Subject: 244 and 250 S Dale

Nick, we have curb and gutter waiver applications at these properties. Could you or Gene review and provide a recommendation?

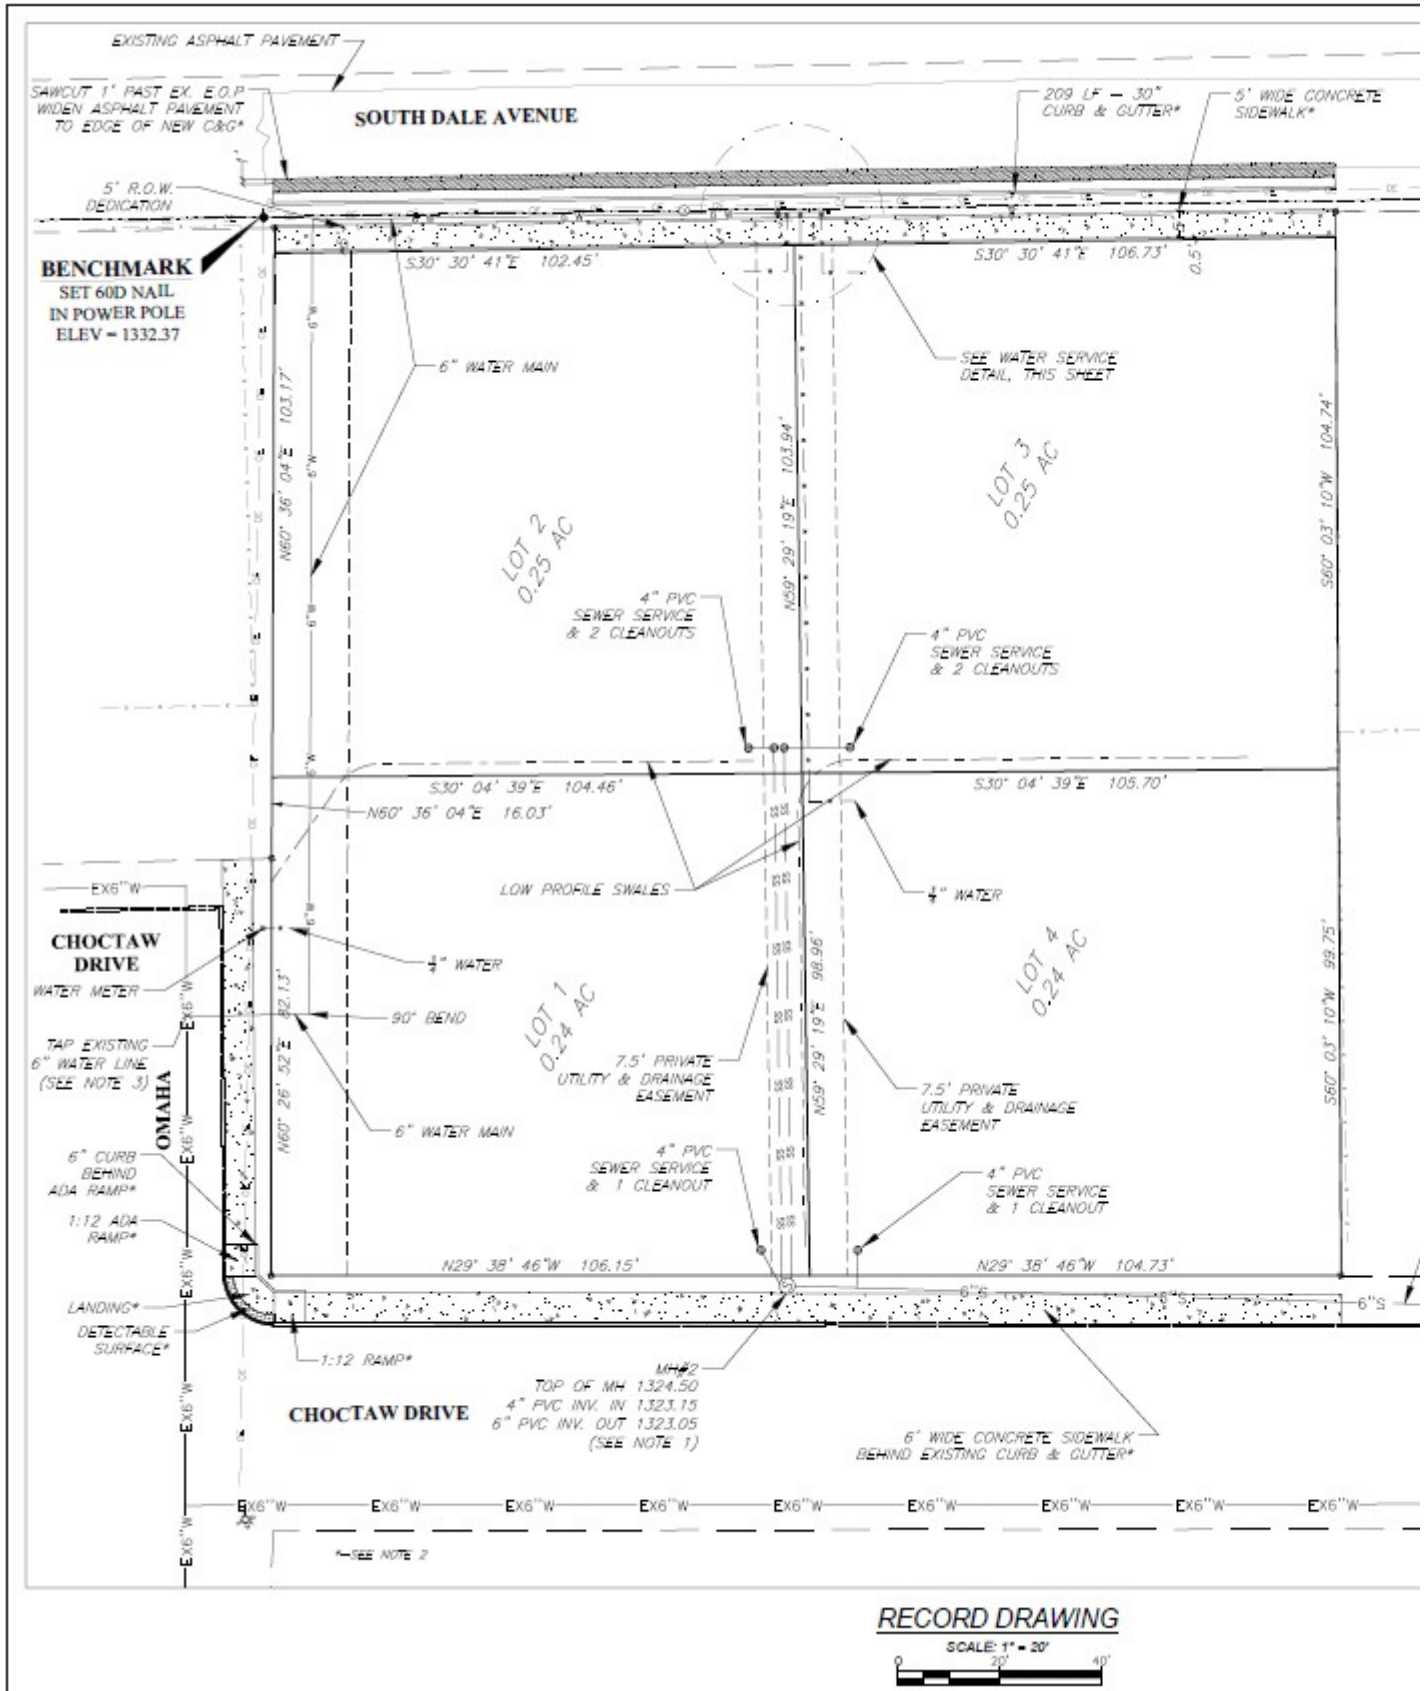
The 5-ft. wide sidewalk, curb and gutter, and pavement widening are shown on the Record Drawings below. All items need to be installed.

“2. * designates items that have not been constructed per the date of this Record Drawing but are depicted as indicated on approved construction drawings for reference only. Sidewalks, Curb and gutter, and pavement widening to be constructed after lots are developed and driveway curb cuts are located.”
